**Harker Heights
Planning and Zoning
Commission
Meeting & Workshop**

PRELIMINARY PLAT OF: STONE LAKE TRAILS F.M. 2410, Bell County Rural, Texas

**MASTER UTILITY PLAN OF:
STONE LAKE TRAILS**
134.832 ACRES 5,873,300.37 S.F.
117 LOTS, 3 BLOCKS AND 4 TRACTS INCLUDING:
11,157.41 L.F. OF NEW STREETS AND 698,422.79 S.F. OF R.O.W.
JOHN HUGHES SURVEY, ABSTRACT #379, BELL COUNTY TEXAS
A SUBDIVISION IN THE ETJ CITY OF HARKER HEIGHTS, BELL COUNTY TEXAS

Plat Distributed to HH Staff: June 3, 2021

BEFORE ME, THIS UNDERSIGNED AUTHORITY, ON THIS DAY PERSONALLY APPEARED _____ KNOWN BY ME TO BE THE PERSON WHOSE NAME IS SUBSCRIBED TO THE FOREGOING INSTRUMENT. IT HAS BEEN ACKNOWLEDGED TO ME THAT HE/SHE EXECUTED THE FOREGOING INSTRUMENT AS THE OWNER OF THE PROPERTY DESCRIBED HEREOF.

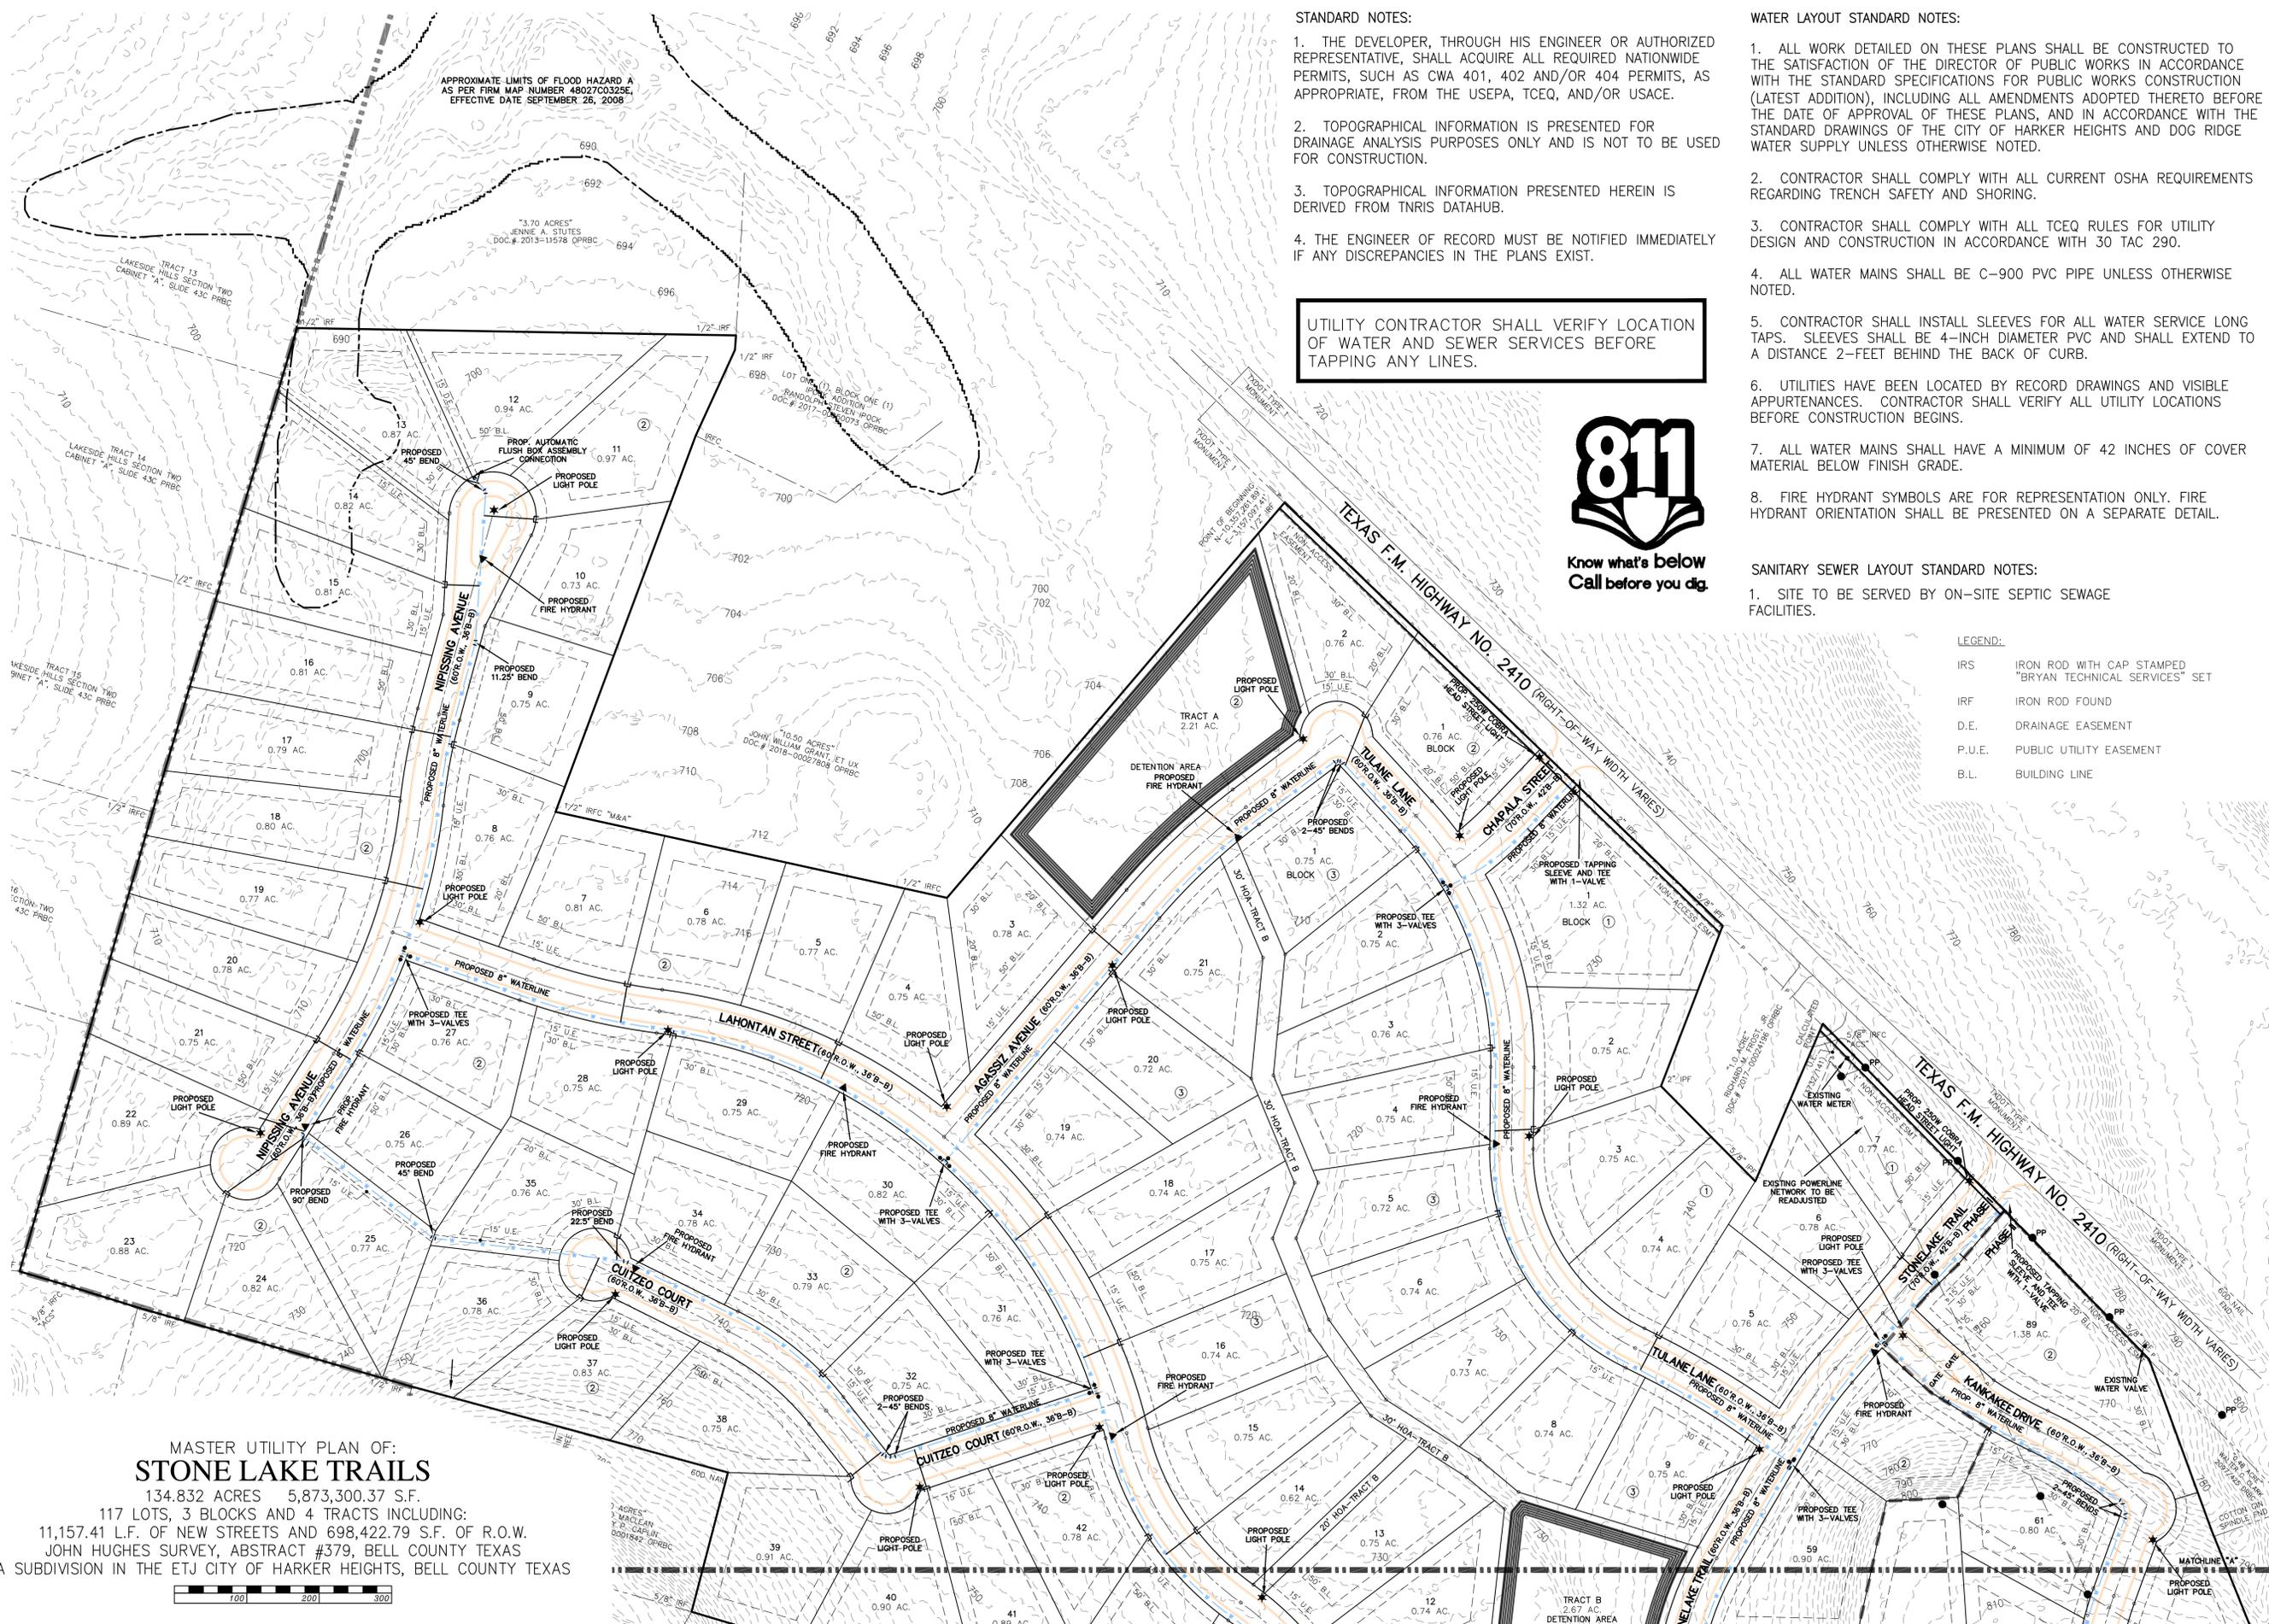
1. Applicant is advised that a concept plan submission is required prior to or with submission of a preliminary plat per §154.20(A)(2)(e).
2. Applicant shall provide a detail with typical building placements and building envelopes.

3. Applicant shall provide half of the lacking right of way to meet the 120' required width along those lots that abut FM 2410 (major arterial).
4. Per §154.37(D)(7), Applicant shall amend the subdivision layout such that the length of Kankakee Drive does not exceed the allowable culdesac length for lots less than 1 acre.

7. Applicant shall clarify the sheet and phase linework such that they are discernable in black & white and when reproduced (different line types).
8. On page 1 of the plat dedication pages, applicant shall provide uniform annotation for all surrounding parcels (lot/block information, subdivision name, type of use for a distance of 300 ft from the plat boundary).

12. Per §154.20(B)(6) applicant shall provide an as-built for the existing property (structures, OSSF, easements). On some of the plan sheets two structures are shown to be located on Lot 80, Block 2. Clarify the intent for those existing structures.

13. Applicant shall clarify the intent for the existing well located on Lot 76, Block 2.

15. Applicant shall provide for utility easements to the adjacent undeveloped parcels.
16. Applicant shall address how the two landlocked parcels south of Lots 36-38 of Block 2 are accessed (connectivity to public ROW).

17. Applicant shall provide for half of the right of way needed to bring the adjacent Gnome Drive into compliance (Lots 77-80 need to dedicate 5' of ROW) & need to illustrate the same for opposite side (Full ROW should be 70'), same for Lago Vista Drive.

18. Provide concurrence from TXDOT showing approval for curb cuts and drainage acceptance.
19. Applicant is advised that all drainage infrastructure shall be completed in Phase 1 of this development or waivers of liability will need to be executed and recorded.

1. Applicant is advised that a concept plan submission is required prior to or with submission of a preliminary plat per §154.20(A)(2)(e). **6/17/21 Not Met. Applicant's response is noted. However, a Concept Plan application was not submitted with the revisions.**

2. Applicant shall provide a detail with typical building placements and building envelopes. **6/17/21 Partially Met. Applicant's response is noted. However, applicant shall amend Surveyor's note #12 such that it is clear that those are the current setbacks at the time of platting and that setbacks are determined by the adopted zoning district as mended by City Council.**

3. Applicant shall provide half of the lacking right of way to meet the 120' required width along those lots that abut FM 2410 (major arterial). **6/17/21 Partially Met. The right of way dedication being offered with this platting action must be reflected on sheet 1 or a note added to refer to Sheets 2-4 for additional detail.**

7. Applicant shall clarify the sheet and phase linework such that they are discernable in black & white and when reproduced (different line types). **6/17/21 Met.**

8. On page 1 of the plat dedication pages, applicant shall provide uniform annotation for all surrounding parcels (lot/block information, subdivision name, type of use for a distance of

300 ft from the plat boundary). **6/17/21 Not Met.** The following clarification is provided per the applicant's request. One Sheet 1 some parcels that are adjacent to this development are labeled by lots and blocks (The Escarpment Subdivision; Lakeside Hills Subdivision), while others are only identified by the subdivision name (Colinas Del Lago). Additionally, code requires that the usage of the lots within 300 feet of the property boundary be identified. If they are all the same use then that can be added in a note on Sheet 1.

9. Applicant shall illustrate the adjacent offsite and onsite existing 20' drainage easement and address connectivity of said easement (Lots 49-56, Block 2, & Tract C). This point discharge shall be taken into account in the drainage analysis. **06/17/21 Partially Met.** The applicant shall illustrate and annotate all drainage easements (yellow) that continue onto this property and ensure that the existing 15' waterline easement by separate instrument (blue highlight) is shown in the proposed subdivision. Applicant shall provide a copy of the water line easement recorded by separate instrument. Applicant shall verify if there are natural swales or low spots in the existing drainage easement and address how the flow will be conveyed from those locations to the proposed Drainage Tract C and not into a proposed home.

1. Applicant is advised that a concept plan submission is required prior to or with submission of a preliminary plat per §154.20(A)(2)(e). **Noted**
2. Applicant shall provide a detail with typical building placements and building envelopes. **Building setbacks have been provided for each lot.**

3. Applicant shall provide half of the lacking right of way to meet the 120' required width along those lots that abut FM 2410 (major arterial). **ROW dedication lines added to get 120' required for FM 2410.**

6. Applicant shall move the drainage tracts dedication from the subdivision block to after the dedication statement and before the applicant's signature. **Drainage tract dedication added after dedication statement and before applicant's signature. These drainage tracts to be owned and maintained by the Home Owners Association.**

7. Applicant shall clarify the sheet and phase linework such that they are discernable in black & white and when reproduced (different line types). **Linework for changed to add variation between phasing lines and sheet lines.**

8. On page 1 of the plat dedication pages, applicant shall provide uniform annotation for all surrounding parcels (lot/block information, subdivision name, type of use for a distance of 300 ft from the plat boundary). **Comment needs clarification.**

11. On all plat dedication pages, the applicant shall identify usage and ownership for all Tracts (A, B, C & D) in a uniform manner (i.e. each have Tract name and acreage with a note for usage and ownership on the dedication page. On Sheet 5 on the plat, a table is given showing the tract name, acreage, ownership and usage.

12. Per §154.20(B)(6) applicant shall provide an as-built for the existing property (structures, OSSF, easements). On some of the plan sheets two structures are shown to be located on Lot 80, Block 2. Clarify the intent for those existing structures. Please see the attached as-builts for the existing structure. Septic permit and information is also included. Existing easements for this structure were added to the plat.

13. Applicant shall clarify the intent for the existing well located on Lot 76, Block 2. The proposed well is to used for landscape irrigation for Lot 76.

15. Applicant shall provide for utility easements to the adjacent undeveloped parcels. Need clarification for this comment. Which parcels are undeveloped and in need of a utility easement.

17. Applicant shall provide for half of the right of way needed to bring the adjacent Gnome Drive into compliance (Lots 77-80 need to dedicate 5' of ROW) & need to illustrate the same for opposite side (Full ROW should be 70'), same for Lago Vista Drive. See variance letter.

18. Provide concurrence from TXDOT showing approval for curb cuts and drainage acceptance. See attached email showing TxDOT approval of curb cuts. Drainage acceptance to be closer to final plat.

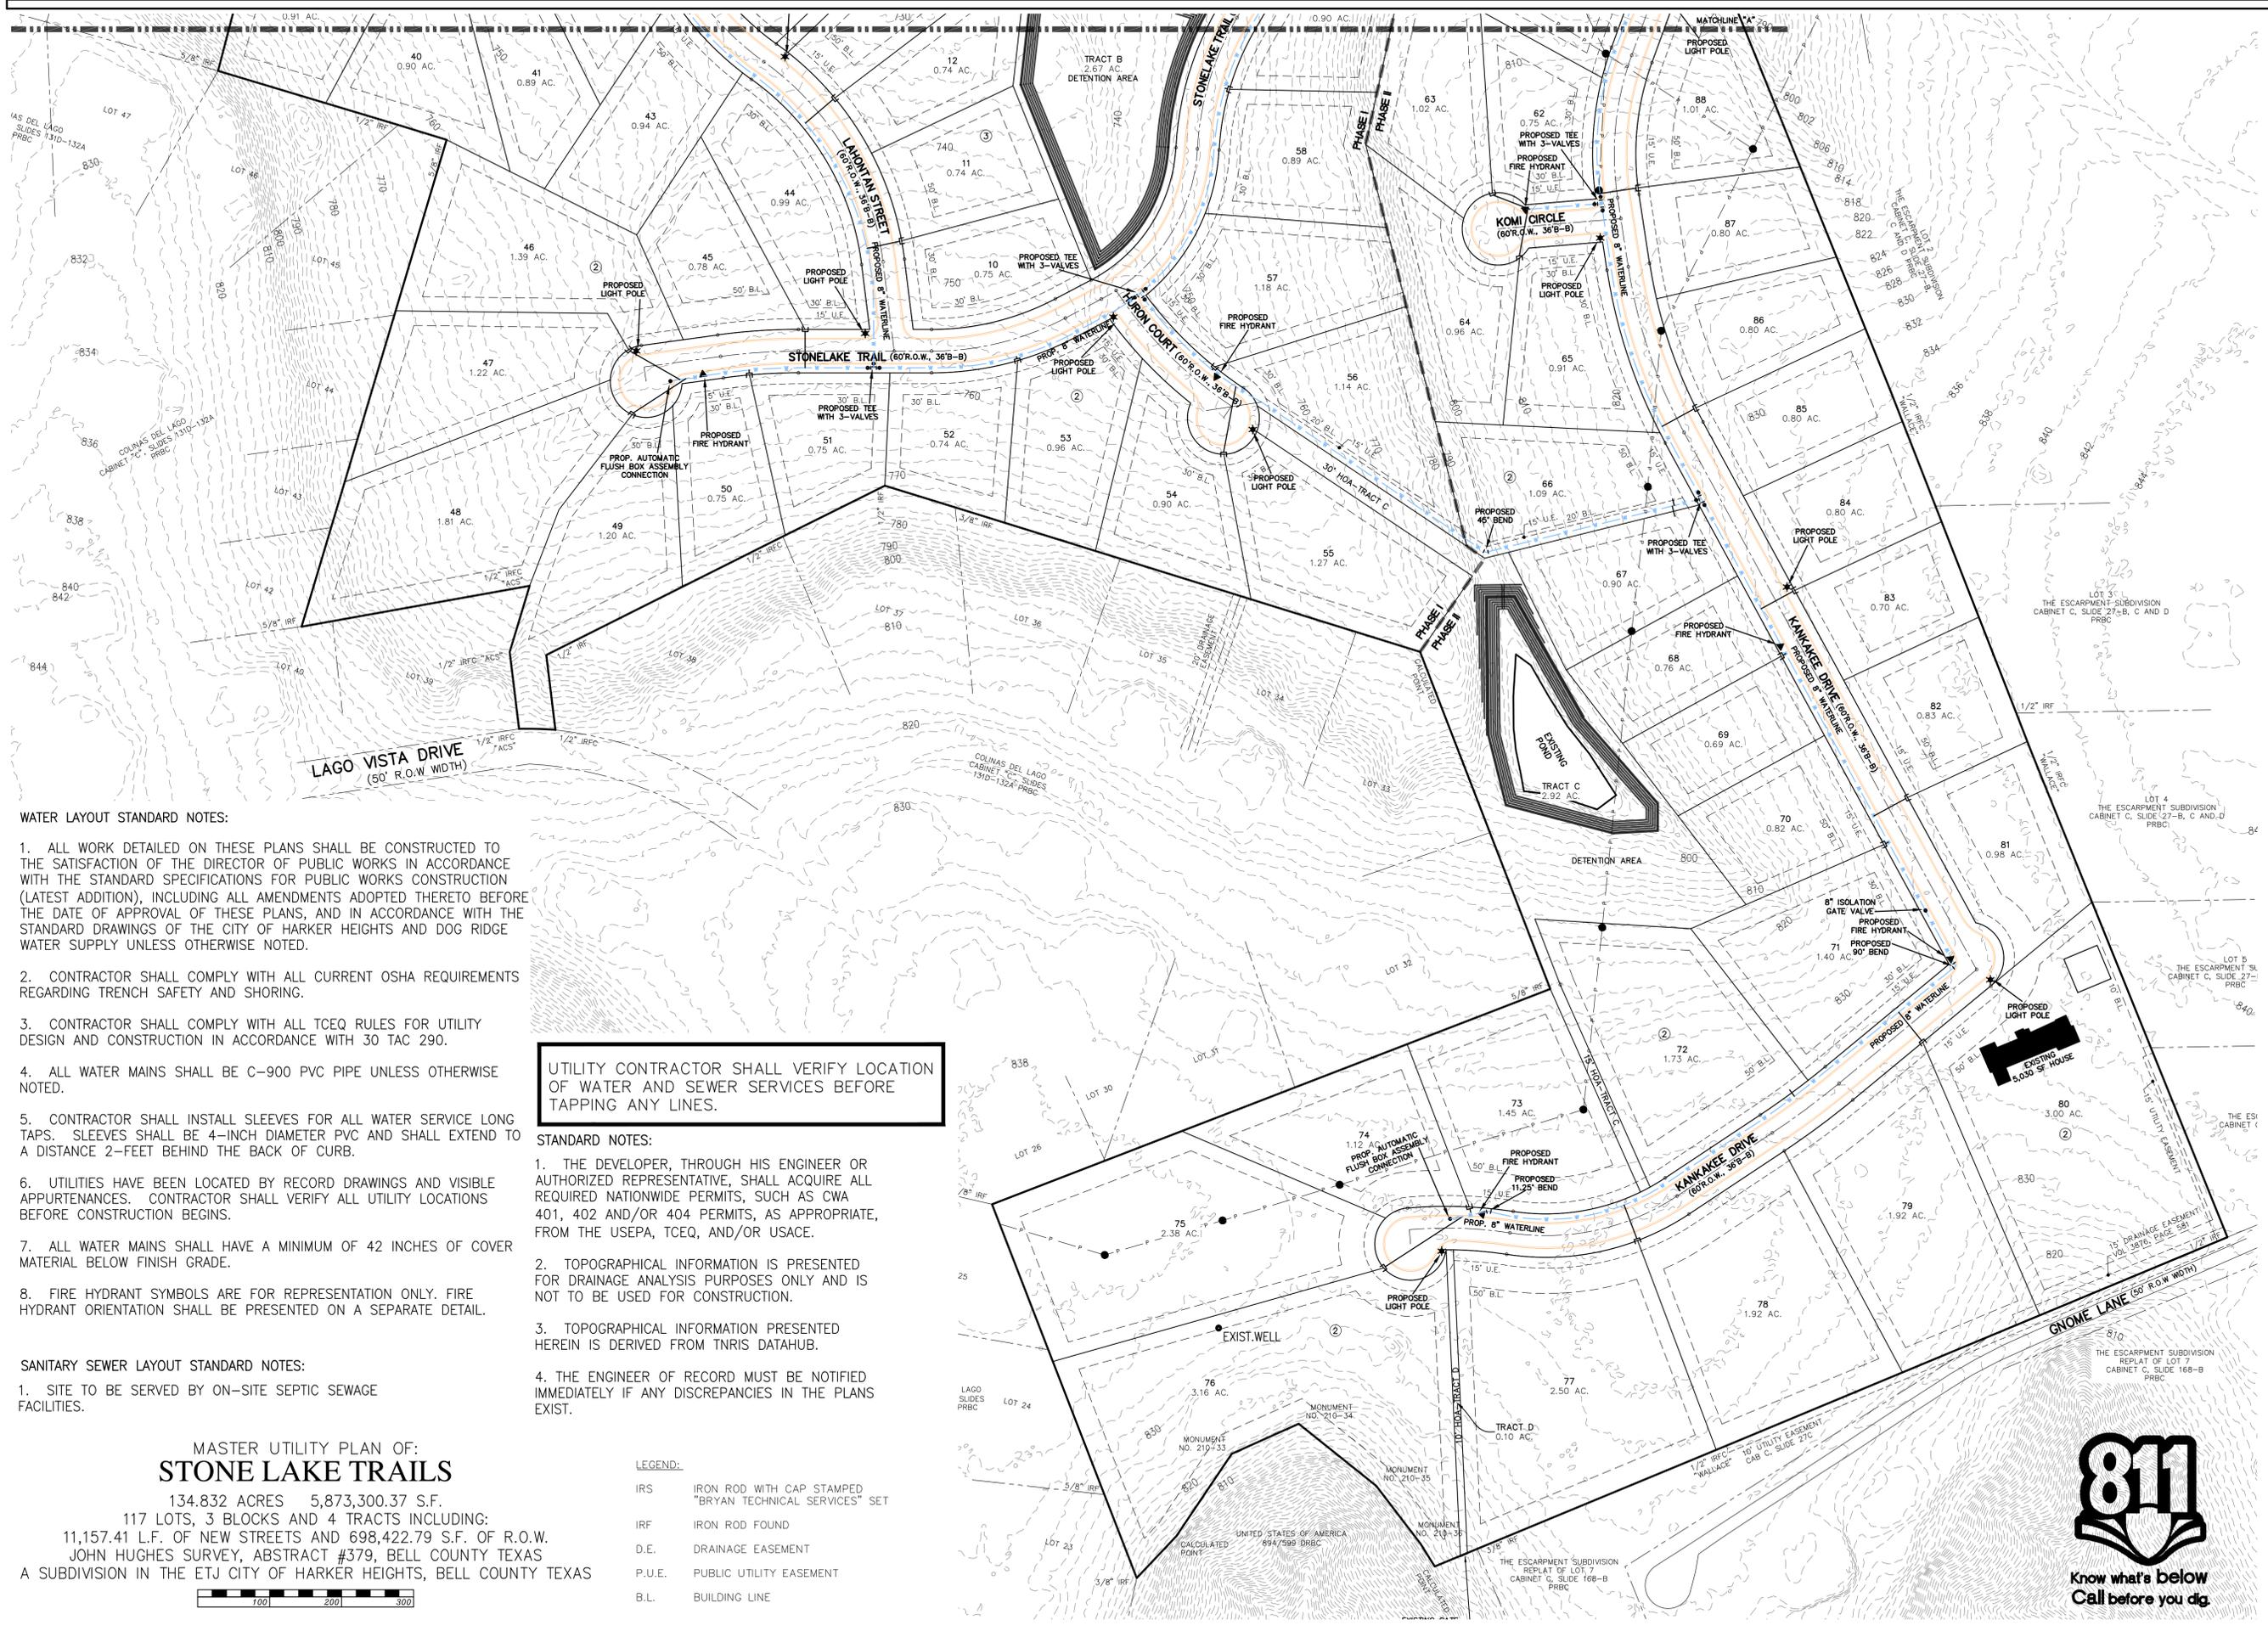
1. Water line tees are required to have isolation gate valves on all three branches of the tee.
2. Add an 8-inch isolation gate valve 75' from the fire hydrant (prior to the 90-degree bend) located on Lot 71 on Kankakee Drive.

3. Loop the water mains between Nipissing Avenue and Cuitzeo Court between Lot's 24 and 25 on Nipissing Avenue and Lot's 36 and 37 on Cuitzeo Court.
4. Add a 15' public utility easement on either side of Lot's 79 and 80 between Kankakee Drive and Gnome Lane.

5. Add a 15' public utility easement within Lot 74 at the end of Kankakee Drive on the west side of the lot line between Lot's 73 and 74, extending to Lot 32 in the Colinas Del Lago subdivision. Then extending the 15' public utility easement west to the lot line between Lot's 31 and 32, Colinas Del Lago.

6. Extend the water line on the Nipissing Avenue north cul-de-sac past the curb preferably where flush water can run between lot lines. Add an automatic flush box assembly connection. Provide a 15' public drainage easement between the lot lines. See the automatic

flush assembly drawing. You will be substituting the fire hydrant in place of the 6-inch flush assembly.

7. Reconfigure the lot line between Lot's 63 and 64 where the water main can be looped between Huron Court and Komi Circle. The water lines would be drawn on the east side of Huron Court and on the south side of Komi Circle. Provide a 15' public utility easement for the loop connection.

8. Add a 15' public utility easement between Lot's 13 and 14 between Nipissing Avenue and the Lakeside Hills subdivision.
9. Add an automatic flush assembly connection at the Kankakee Drive cul-de-sac. Provide a 15' public drainage easement between the lot lines. See the automatic flush assembly drawing. You will be substituting the fire hydrant in place of the 6-inch flush assembly.

10. Add an automatic flush assembly connection at the Stone Lake Trail cul-de-sac. Provide a 15' public drainage easement between the lot lines. See the automatic flush assembly drawing. You will be substituting the fire hydrant in place of the 6-inch flush assembly.

1. This preliminary "Master Utility Plan" does not address the fact that Dog Ridge Water Supply Corporation has a four inch water line originating at an existing Central Texas Water Meter Supply meter vault shown on Sheet C2.0 (Block 1, Lot 7) and going access the plotted

1. Water line tees are required to have isolation gate valves on all three branches of the tee. **Isolation gate valves added to branches of tee.**
2. Add an 8-inch isolation gate valve 75' from the fire hydrant (prior to the 90-degree bend) located on Lot 71 on Kankakee Drive. **8" isolation gate valve added before fire hydrant.**

3. Loop the water mains between Nipissing Avenue and Cuitzeo Court between Lot's 24 and 25 on Nipissing Avenue and Lot's 36 and 37 on Cuitzeo Court. **15' utility easements added on Lots 25 and 35 shown on the final plat. The water line is looped through this segment of utility easements as seen on the utility plan.**

4. Add a 15' public utility easement on either side of Lot's 79 and 80 between Kankakee Drive and Gnome Lane. **See variance letter.**
5. Add a 15' public utility easement within Lot 74 at the end of Kankakee Drive on the west side of the lot line between Lot's 73 and 74, extending to Lot 32 in the Colinas Del Lago subdivision. Then extending the 15' public utility easement west to the lot line between Lot's 31 and 32, Colinas Del Lago. **See variance letter.**

6. Extend the water line on the Nipissing Avenue north cul-de-sac past the curb preferably where flush water can run between lot lines. Add an automatic flush box assembly connection. Provide a 15' public drainage easement between the lot lines. See the automatic flush assembly drawing. You will be substituting the fire hydrant in place of the 6-inch flush assembly. **Flush assembly added near the lot line of 12/13 Block 2. Fire hydrant to remain for fire safety. 15' drainage easement added in between lot line.**

7. Reconfigure the lot line between Lot's 63 and 64 where the water main can be looped between Huron Court and Komi Circle. The water lines would be drawn on the east side of Huron Court and on the south side of Komi Circle. Provide a 15' public utility easement for the loop connection. **See utility plan for the proposed water loop. Water line is to run along tract C/ Lot 56 and Lot 66/67. 15' utility easements were added. Grade change between Komi and Huron is significant. More acceptable slopes are available with the proposed loop.**

8. Add a 15' public utility easement between Lot's 13 and 14 between Nipissing Avenue and the Lakeside Hills subdivision. **15' utility easement added between Lot 13/14.**
9. Add an automatic flush assembly connection at the Kankakee Drive cul-de-sac. Provide a 15' public drainage easement between the lot lines. See the automatic flush assembly drawing. You will be substituting the fire hydrant in place of the 6-inch flush assembly. **Flush assembly added at Kankakee Drive. Runoff to run through Tract D.**
10. Add an automatic flush assembly connection at the Stone Lake Trail cul-de-sac. Provide a 15' public drainage easement between the lot lines. See the automatic flush assembly drawing. You will be substituting the fire hydrant in place of the 6-inch flush assembly. **Flush assembly added at Stone Lake Trails. Runoff will travel down Stone Lake Trail and enter Tract B.**
